#### FORD CD4E 3-2 TIMING VALVE CHANGE 02 & UP

**CHANGE:** In the 2002 model year, Ford Motor Company changed the 3-2 Timing Valve Hydraulics.

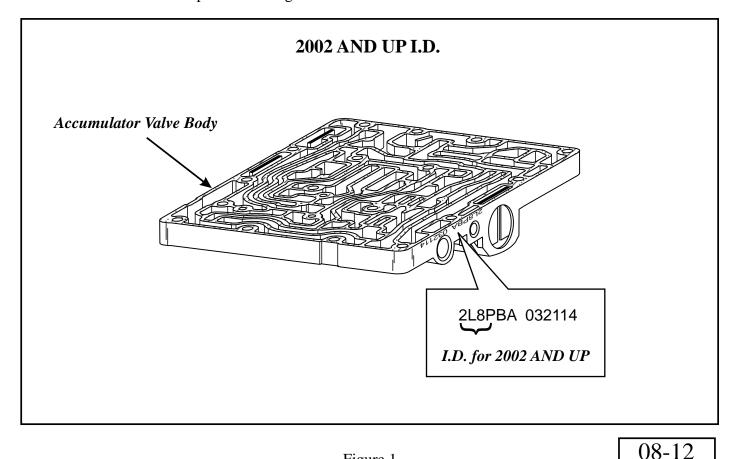
3-2 TIMING VALVE AND SPRING: The 3-2 Timing valve was redesigned as shown in Figure 2 and is now installed into the valve body with the spring first, opposite the previous design. Refer to Figure 1 to see how to identify the Accumulator section of the Valve Body on 2002 and UP. The ink stamp of 2L8P designates 2002 and UP.

# PREVIOUS VERSIONS PARTIAL HYDRAULIC CIRCUIT 3-2 TIMING VALVE POSITION ON A 3-2 DOWNSHIFT

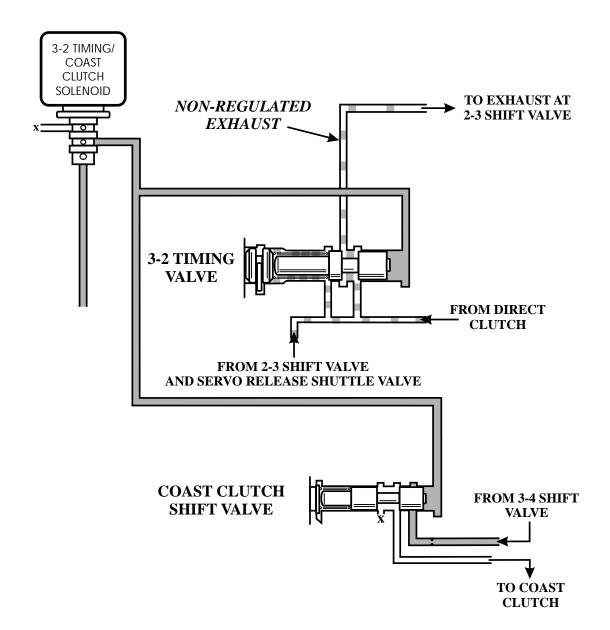
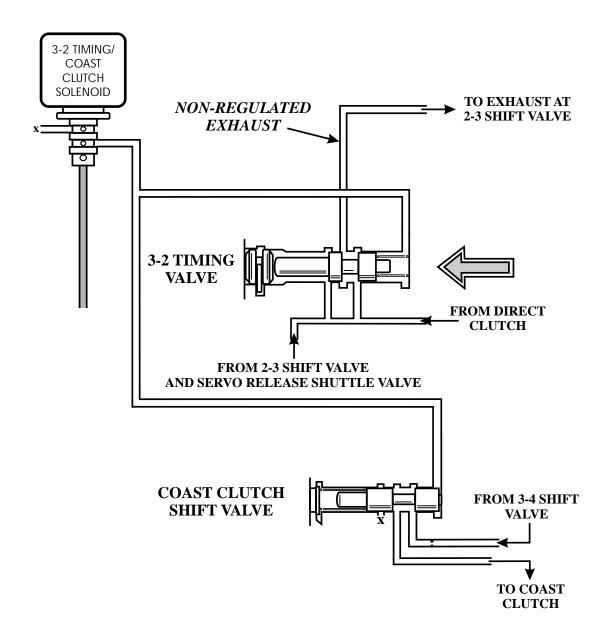
**REASON:** For quicker release of the Direct Clutch during a 3-2 downshift. Figure 3 shows the previous design 3-2 Timing Valve on a 3-2 downshift, notice that the 3-2/CCS Solenoid is at a lower duty cycle providing a regulated exhaust of the Direct Clutch. Figure 4 shows a 3-2 downshift at a higher duty cycle of the 3-2/CCS Solenoid, which will create a quicker "unregulated" exhaust of the Direct Clutch. Figure 5 shows the 2002 and Up Hydraulics, notice that the 3-2 Timing Valve is now held to the left by it's spring, which will created a quicker "unregulated" exhaust of the Direct Clutch regardless of 3-2/CCS duty cycle.

Summary: The 3-2 Timing Valve is forced to the right by its spring tension and Low duty cycle of the 3-2 Timing solenoid to create a regulated exhaust of direct clutch pressure on a 3-2 downshift.

Summary: The 3-2 Timing Valve is moved to the left by high duty cycle of the 3-2 Timing solenoid to create a quick and un-regulated exhaust of direct clutch pressure on a 3-2 downshift.

Summary: The 3-2 Timing Valve is now moved to the left by the spring allowing a quick exhaust of direct clutch pressure regardless of the duty cycle of the 3-2 Timing Solenoid on a 3-2 downshift, creating a more consistent 3-2 downshift.
